August 20, 2001

**Subject: Granville Solvents Site Removal Action – Soil Treatment**

Granville Solvents Site  
Granville, Ohio

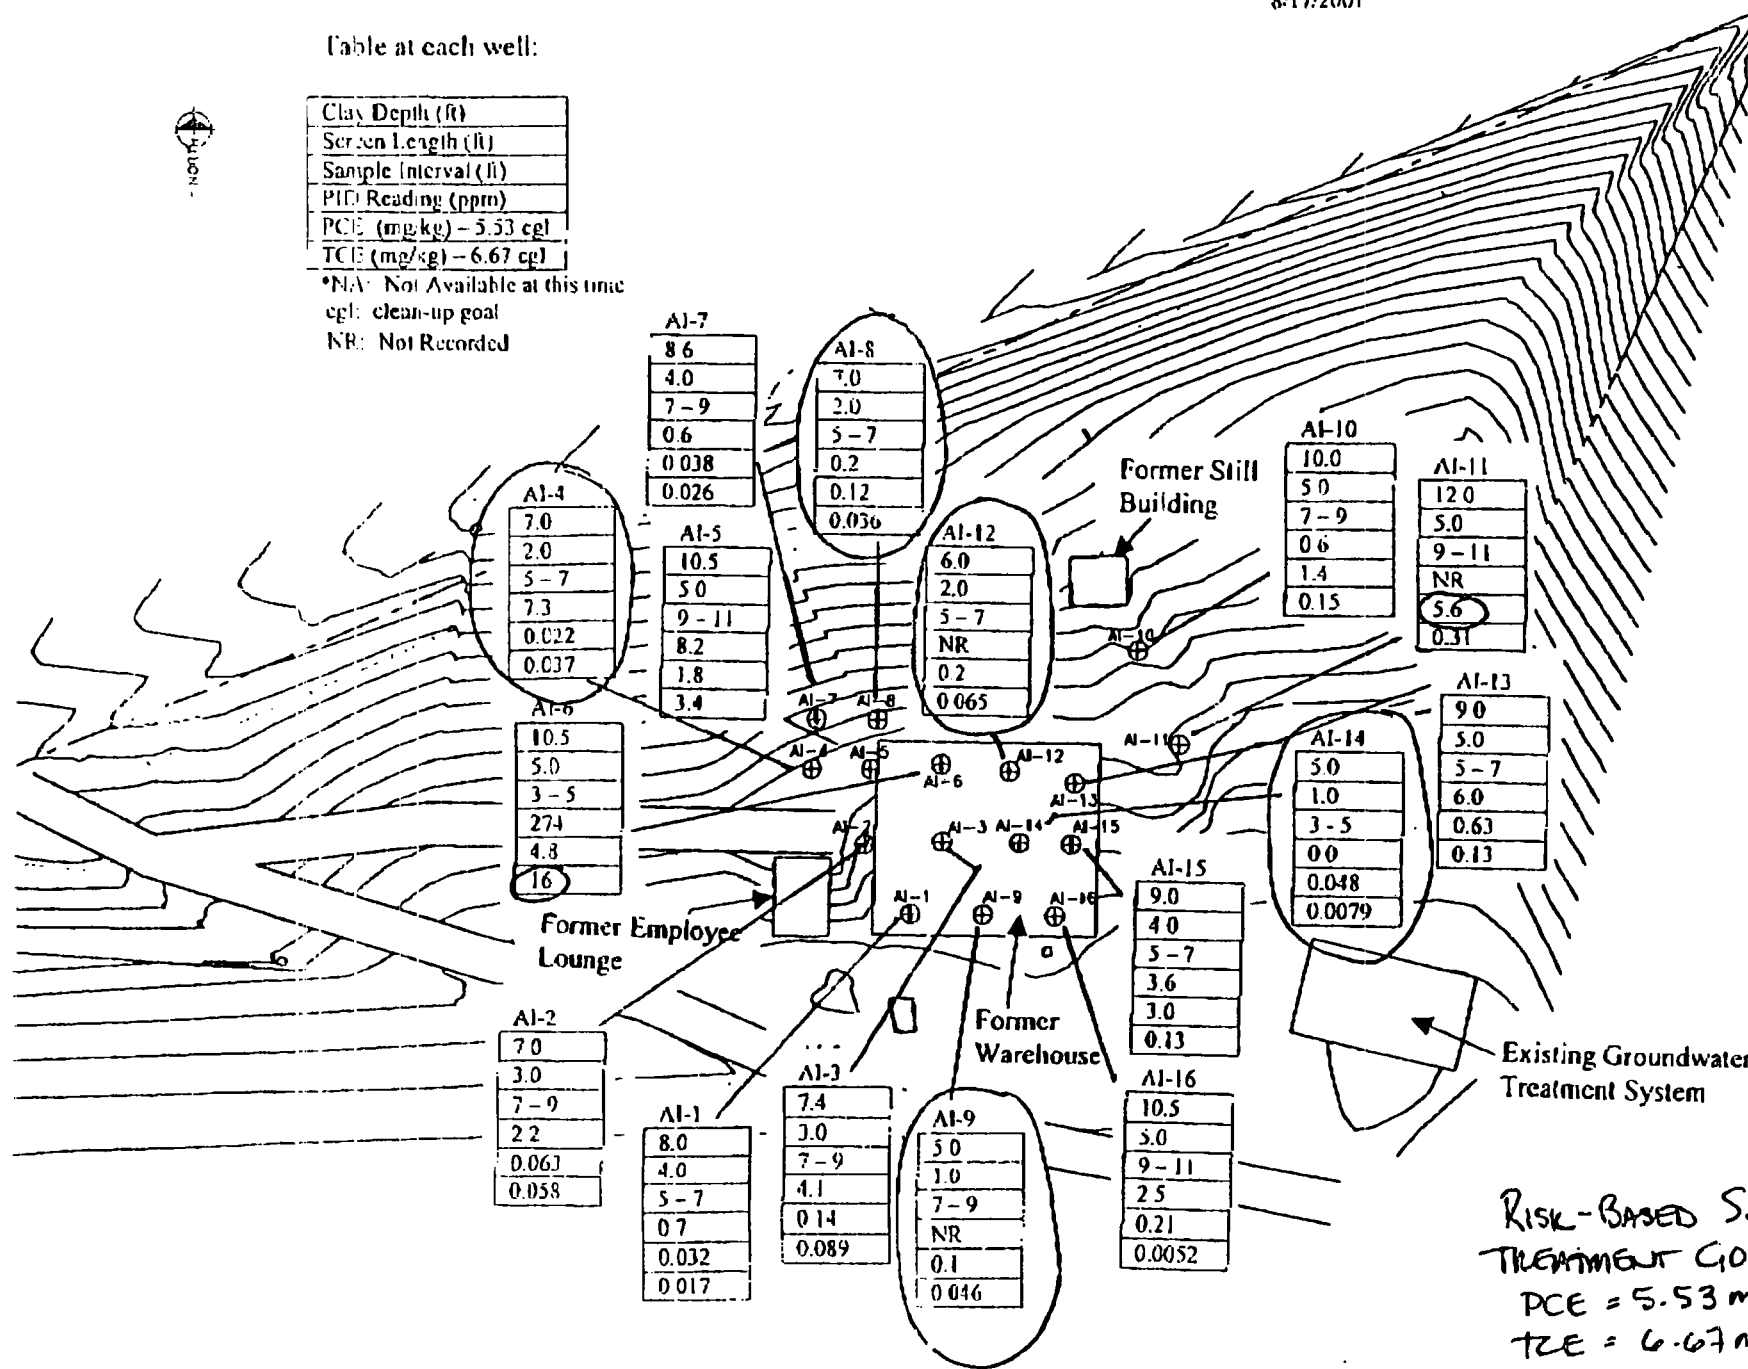
The Granville Solvents Site Group is completing the installation of the air sparging, soil vapor extraction, and air injection wells into soils as outlined in the Air Injection/Soil Vapor Extraction/Air Sparging Design Report, dated February 2001 (the Design Report). During the installation of the air injection wells, we discovered that the clay layer at the site varied in depth and in some areas was less than 10 feet in depth. As a result, we had to install some air injection wells with screens less than 5 feet in length. Of the sixteen air injection wells installed in the clay layer, 10 have wells screens of 4 feet or less. I have attached a site map identifying those wells with screens of 4 feet or less.

The Group also collected and analyzed soil samples from each air injection well to determine the concentration of perchloroethene (PCE) and trichloroethene (TCE). As you can see, the threshold or soil clean-up levels were only exceeded in samples from 2 wells – PCE in well AI-10 and TCE in well AI-6. In both cases, the clay layer was greater than 10 feet in depth and wells with 5-foot screens were installed.

Even though some air injections wells had to be installed with shorter screens than those specified in the Design Report due to shallow clay layers, wells with 5-foot screens were installed in those areas with TCE and PCE concentrations greater than 6.67 mg/kg and 5.53 mg/kg respectively. We believe that the portion of the site with impacted clay will be more than adequately covered by the wells that have been installed and that the concentration of both PCE and TCE will be effectively reduced below the threshold treatment concentrations.
